CITY OF CODY
PLANNING, ZONING AND ADJUSTMENT BOARD
TUESDAY, MAY 24, 2016
CITY HALL COUNCIL CHAMBERS @ 12:00 NOON

CITY OF CODY PLANNING, ZONING AND ADJUSTMENT BOARD STAFF REPORT			
MEETING DATE:	MAY 24, 2016	***TYPE OF ACTION NEEDED***	
AGENDA ITEM:		P&Z BOARD APPROVAL:	X
SUBJECT:	SITE PLAN REVIEW: MODIFICATIONS TO WHITLOCK MOTORS PROJECT. SPR 2016-15	RECOMMENDATION TO COUNCIL:	
PREPARED BY:	TODD STOWELL, CITY PLANNER	DISCUSSION ONLY:

CITY OF CODY PLANNING, ZONING AND ADJUSTMENT BOARD STAFF REPORT			
MEETING DATE:	MAY 24, 2016	***TYPE OF ACTION NEEDED***	
AGENDA ITEM:		P&Z BOARD APPROVAL:	X
SUBJECT:	BEST WESTERN SUNSET MOTOR INN PERGOLA AND OUTDOOR SEATING SPR 2016-1	RECOMMENDATION TO COUNCIL:	
PREPARED BY:	TODD STOWELL, CITY PLANNER	DISCUSSION ONLY:

CITY OF CODY PLANNING, ZONING AND ADJUSTMENT BOARD STAFF REPORT			
MEETING DATE:	MAY 24, 2016	***TYPE OF ACTION NEEDED***	
AGENDA ITEM:		P&Z BOARD APPROVAL:	X
SUBJECT:	SITE PLAN REVIEW—CODY STAMPEDE OUTDOOR ARENA AND HORSE BARNS. SPR 2016-16	RECOMMENDATION TO COUNCIL:	
PREPARED BY:	TODD STOWELL	DISCUSSION ONLY:

TITLE: PROPOSED SITE PLAN

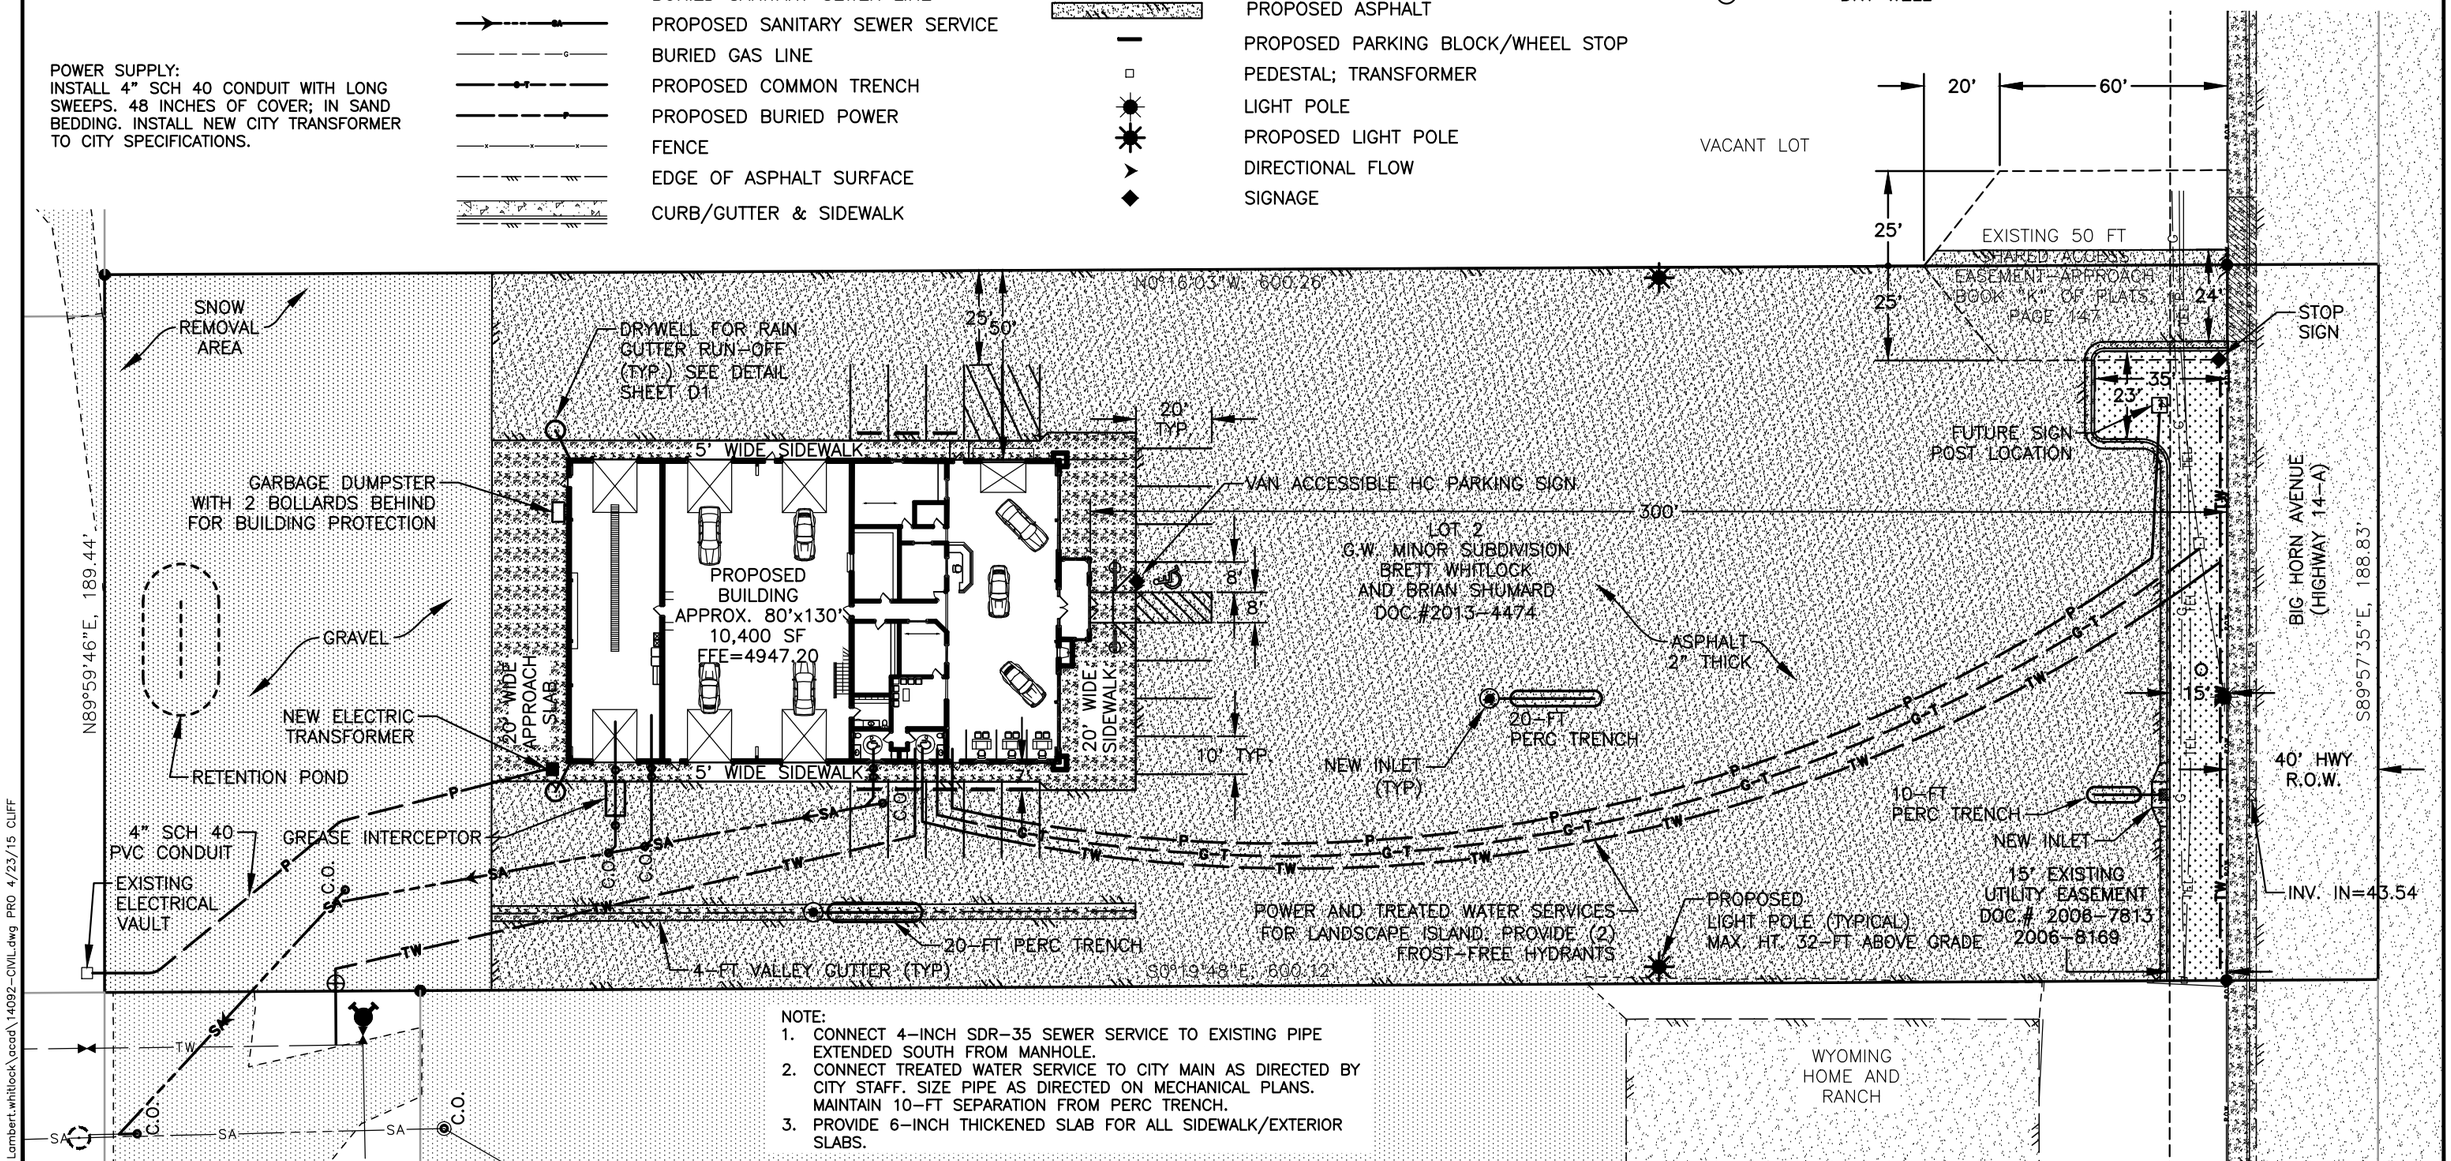
No access or parking changes from the prior review are proposed. As noted previously, access to and from the site is through an existing shared approach to Big Horn Avenue. All but the landscape area and the area at the back of the property will be paved with asphalt or concrete. The boundaries of the vehicle display area are not identified on the site plan, which is not of great concern provided a clear access route that is at least 20 feet wide and maneuverable by emergency vehicles is always available to the building. Due to multiple possible routes, the route was not required to be shown on the site plan. It is also noted that a minimum 24-foot (30' recommended) backup area/parking lot aisle needs to be left clear behind all parking spaces.

Utility Services
The building will utilize domestic water, power, gas, and sewer service, as shown on the site plan. The locations of the service lines are generally acceptable, but some of the details are lacking or need corrected.

For electrical service, a new 3-phase transformer and service line are needed. The route of the electrical service as shown will need an easement from the adjacent property owner. Alternatively it can be routed to the utility easement to the west along Pintail Street, make a 90-degree turn towards the building, and maintain a sweeping run directly to the transformer. The situation must be correctly shown on the plans submitted for the building permit.

It is recommended that all sewer clean outs and water valves in driving areas be protected with concrete collars.

1. Applicable city utility fees (water, sewer, power) are to be paid prior to building permit issuance.
2. On the plans submitted with the building permit, correctly show the route of the electrical line as discussed in the staff report, or obtain a utility easement from the neighbor for the route.
3. Provide an electrical easement for the transformer and electrical line, as specified by the electrical division.
4. Locate the freestanding sign post so that the future sign is not within and does not overhang the utility easement.

5. Protect the sewer clean-outs and storm water inlets in the driving lanes with concrete collars.
6. File with the WY DEQ Water Quality Division the necessary application form for the Class V Underground Injection Control (UIC) wells, and modify the perc trench detail as needed to comply with their requirements.
7. The project must otherwise comply with the site plan and applicable building, fire, and electrical codes.
8. The storm water facilities are to be inspected and certified by the applicant's engineer that they were completed according to approved plans, prior to issuance of a certificate of occupancy.
9. Provide an "as-constructed" site plan prior to issuance of the certificate of occupancy.
10. A building permit must be obtained within two years or this authorization will expire.

TITLE: SITE GRADING PLAN

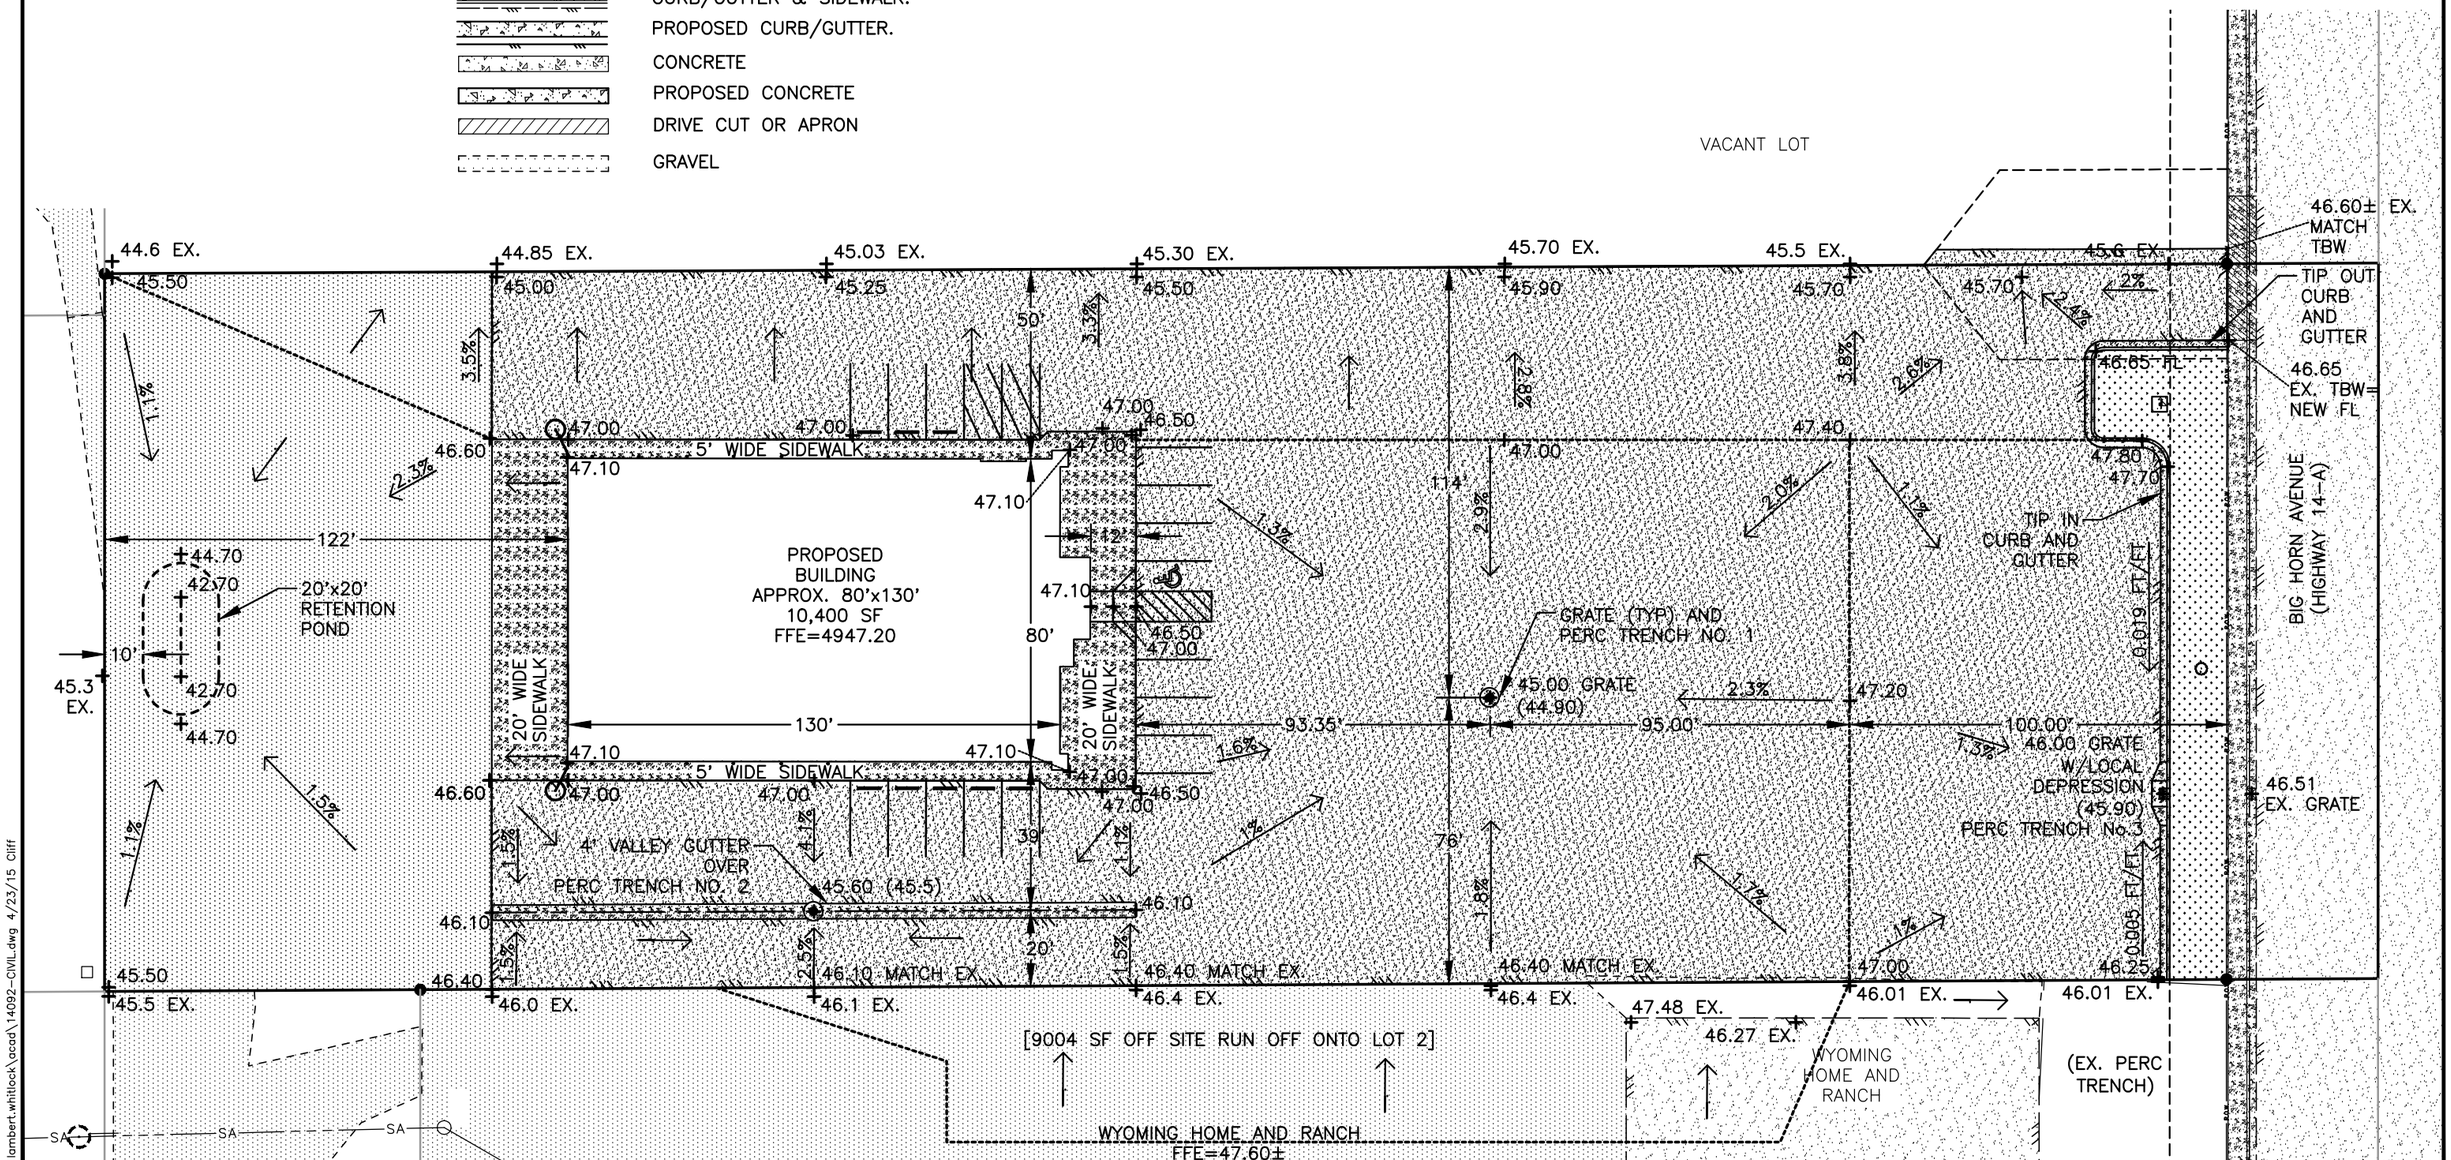
Storm Water Plan:
An engineered storm water plan has been submitted and reviewed by the City Engineer. The grading is properly designed to collect the storm water and retain it in accordance with the city storm water policy manual. Compliance with DEQ registration of the infiltration trenches will be needed as part of the process, which may also include some modification to the inlet detail. (New requirement)

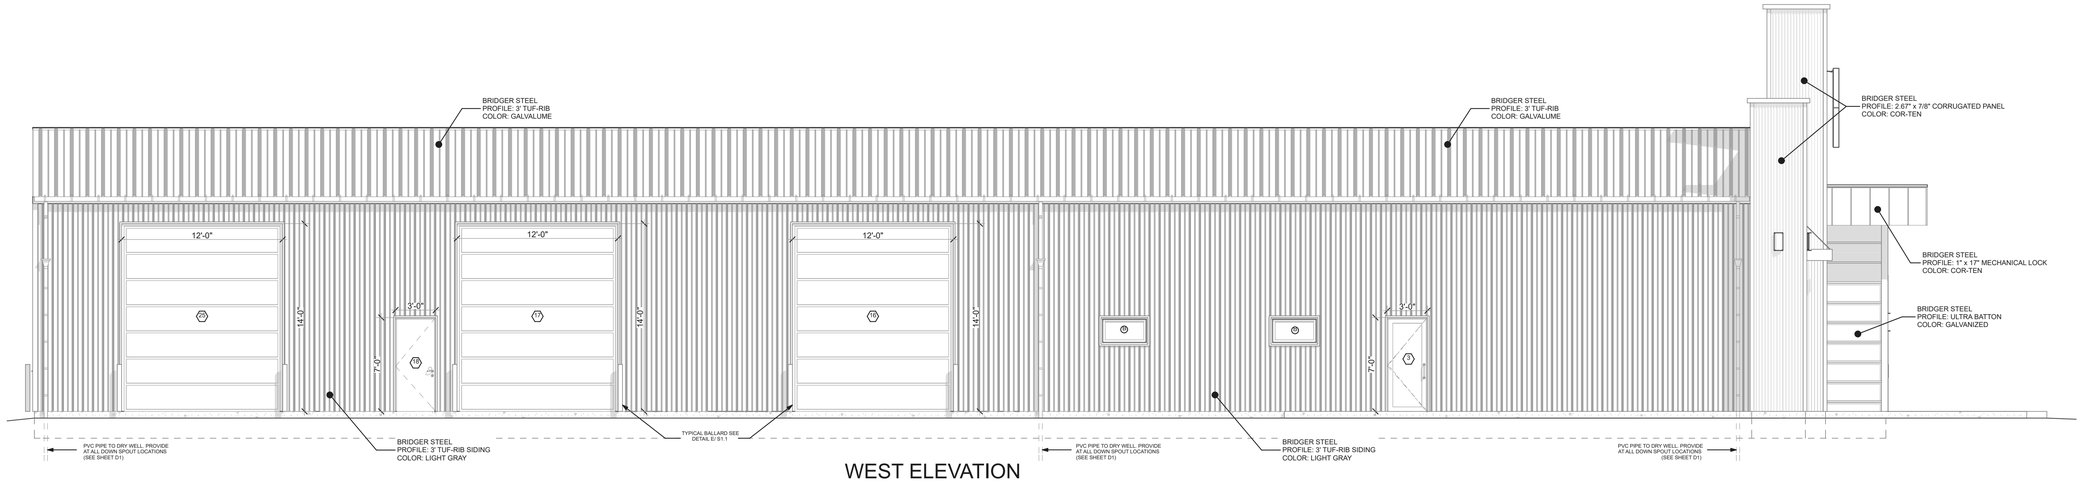
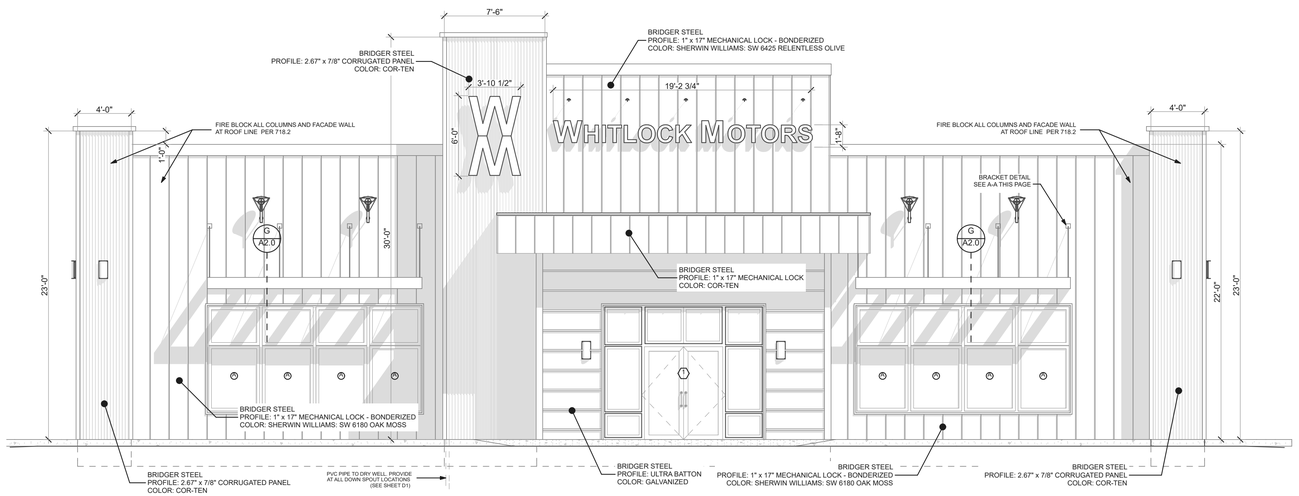
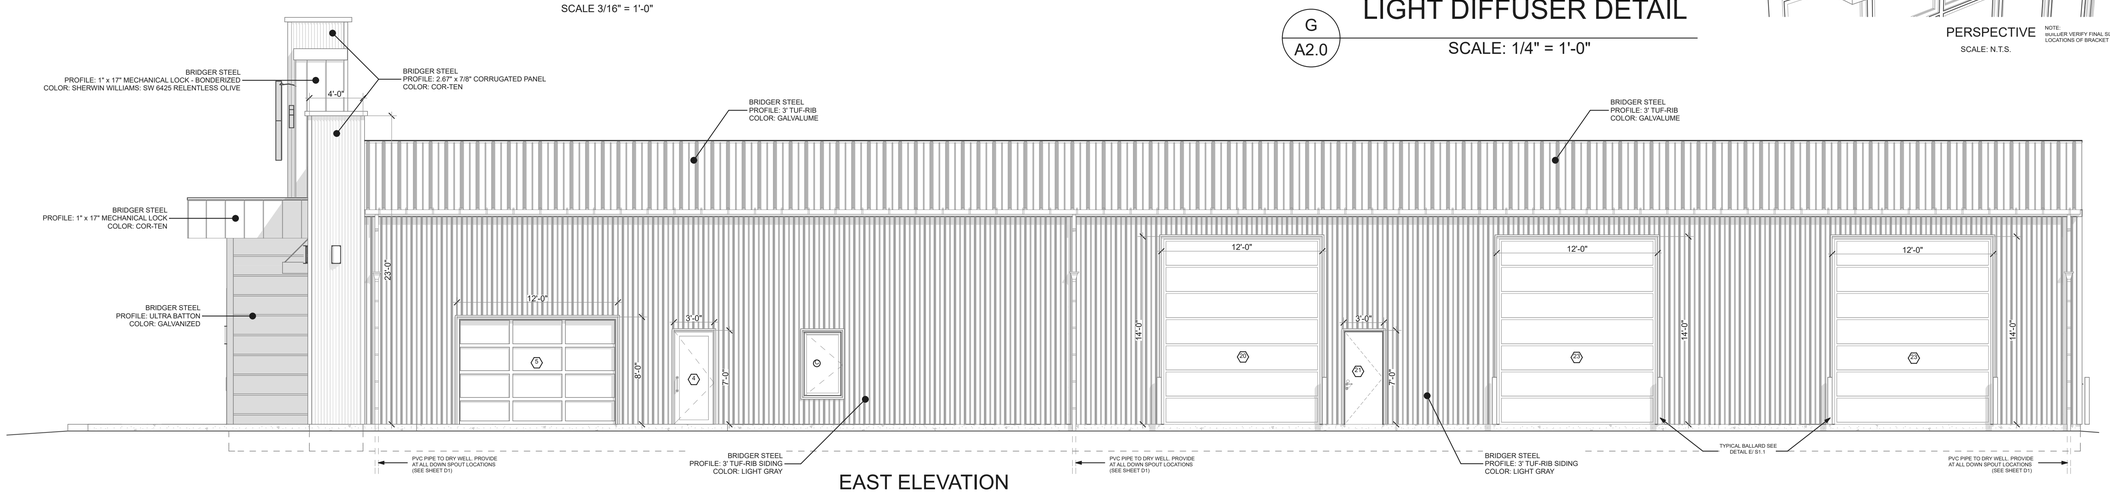
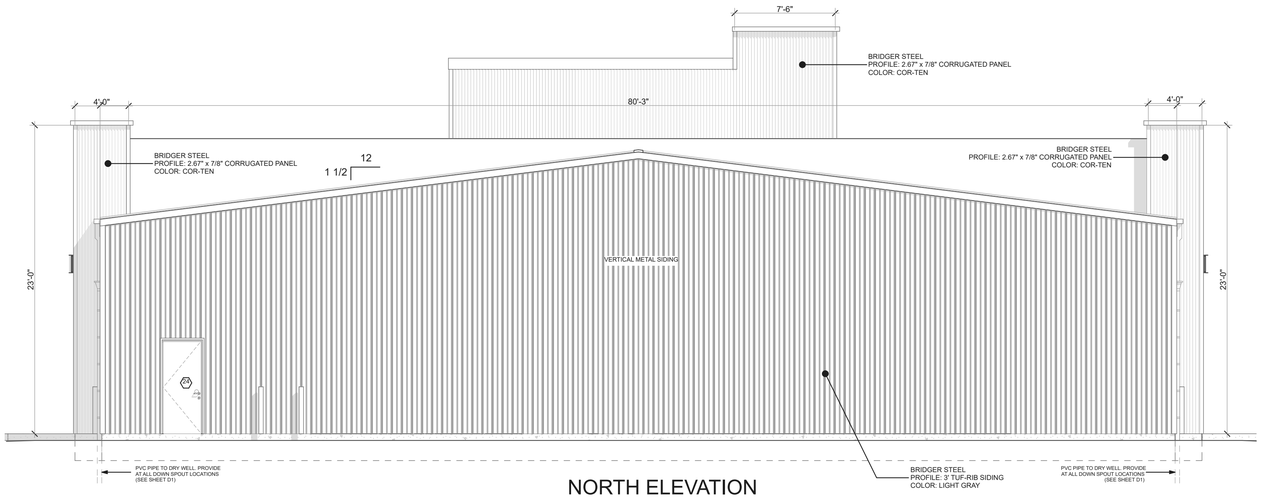
Architecture:
The current proposal is an all-metal clad building, with a standard galvalume roof and light gray vertical rib panels on the sides and back of the building. The front of the building includes “oak moss” colored standing seam vertical panels on the main building wall and parapets, a horizontal batten-style galvanized siding on the entry vestibule, and rust-in-place corrugated panels at the building corners and fireplace bump out. Glass storefront windows with suspended metal canopies are also included.

Admittedly, the original proposal was more architecturally extensive, yet the current proposal is still at least a step above what would be considered the basic steel building package. The variation in types of metal siding and the color coordinated green and rust colors of the façade have a nice look. The storefront windows, while not as large as in the original proposal, are a good addition.

The Board will need to determine if the architectural features of the building are acceptable.
